0 FRAMING PLAN - 3RD FLOOR
S212 1/8" = 1'-0"

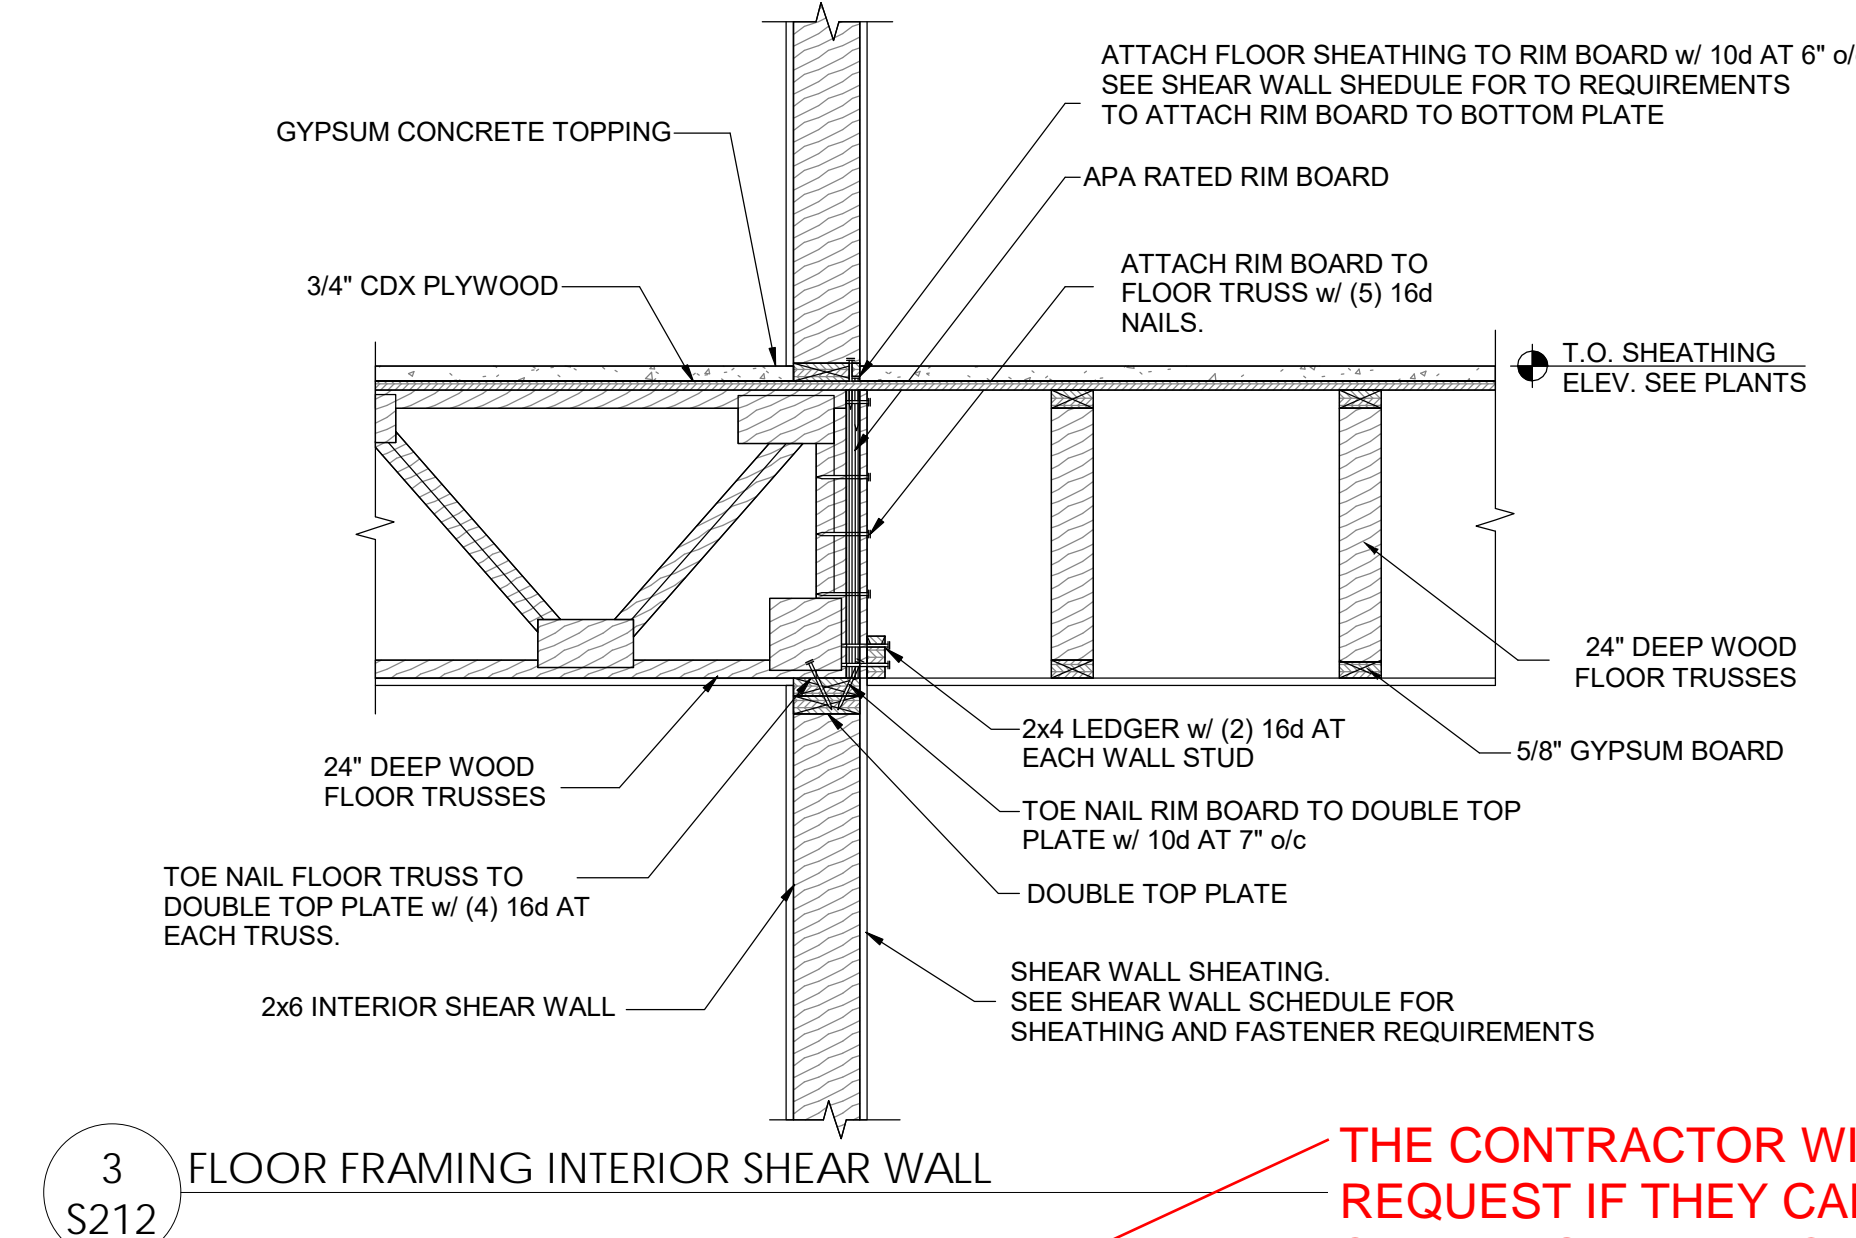
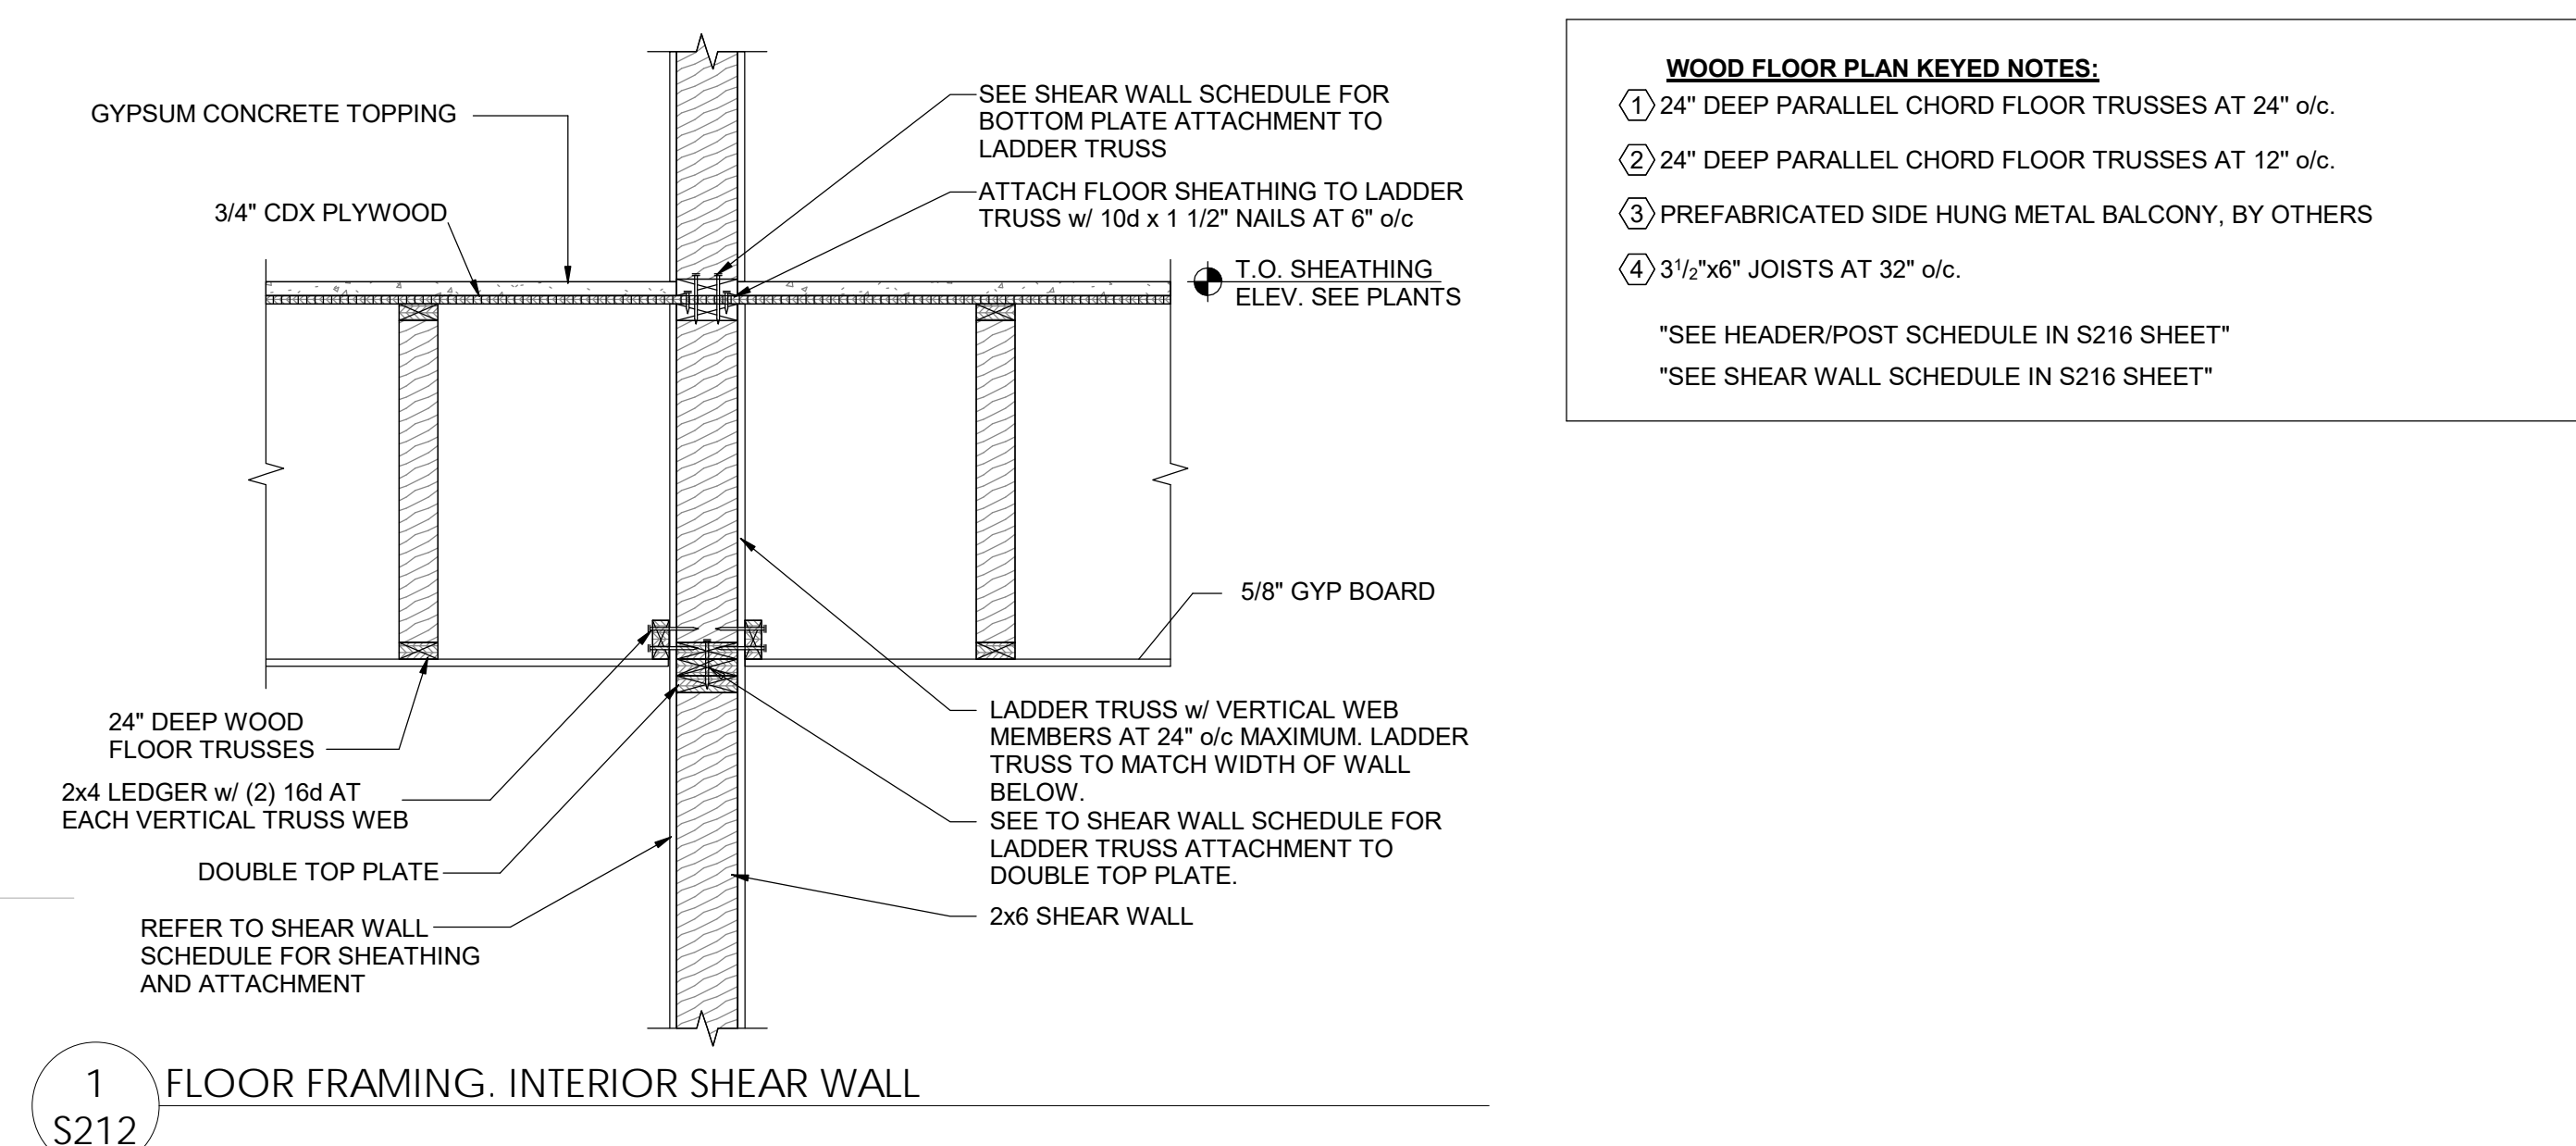
DETAILS AND LOADS FROM THE BALCONY
HANGERS WILL NEED TO BE SHOWN SOME WHERE
SO THE TRUSS SUPPLIER CAN ACCOUNT FOR ANY
HORIZONTAL LOAD THAT MAY BE TRANSFERRED
INTO THE FLOOR/TRUSSES

THE CONTRACTOR WILL PROBABLY REQUEST IF THEY CAN USE OSB SHEATING IN LIEU OF THE PLYWOOD. THE OSB USE IS PRETTY TYPICAL IN THIS AREA. AS LONG AS IT IS APA RATED I ALLOW THE USE OF THE OSB
